SUBJECT: Transmittal of Revised Responses to AP1000 DSER Open Items

**AP1000 Design Certification Review
Draft Safety Evaluation Report Open Item Non-Proprietary Responses**

DSER Open Item Number: 15.2.7-1 Item 10 Revision 2

Figure 1 – IRWST / Containment Recirc Sketch

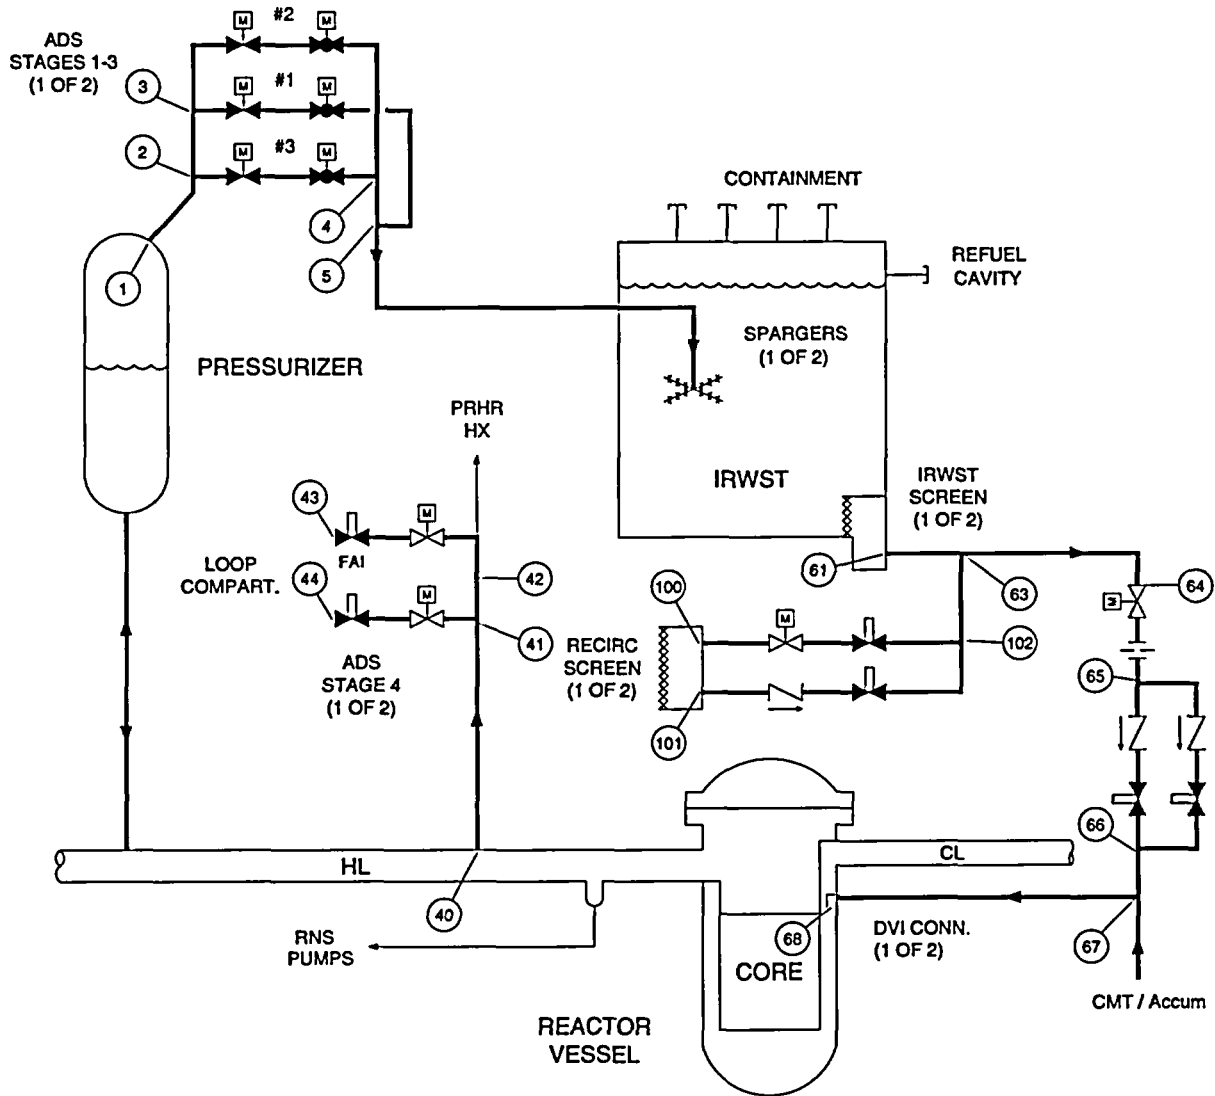
The NRC staff is attempting to modify the RELAP5 AP1000 model to evaluate LTC. The current model does not model sump recirculation into the DVI lines. Please provide the following information to enable the staff to perform LTC confirmatory analyses with RELAP5 for a postulated double DVI line break.

- A. Containment temperature, pressure, water level and boric acid concentration versus time for 30 days.
- B. Recirculation line lengths, areas, elevations and resistances. All elevations including containment water levels should be given relative to the reactor vessel DVI nozzle elevation.
- C. Recirculation valve actuation setpoints and the WCOBRA/TRAC calculated time for sump recirculation following a double ended DVI line break.
- D. Sump screen resistance as a function of flow blockage.

Revision 2 of this response is to change Figure 1 to show that the sump line MOV is normally open, and to add Figure 2 to show the DVI line relationship to the loop configuration more clearly.

- B. The IRWST recirc line flow resistances, inside diameters and volumes are listed in Table 1. Figure 1 shows a sketch of the PXS IRWST / Containment Recirc lines.
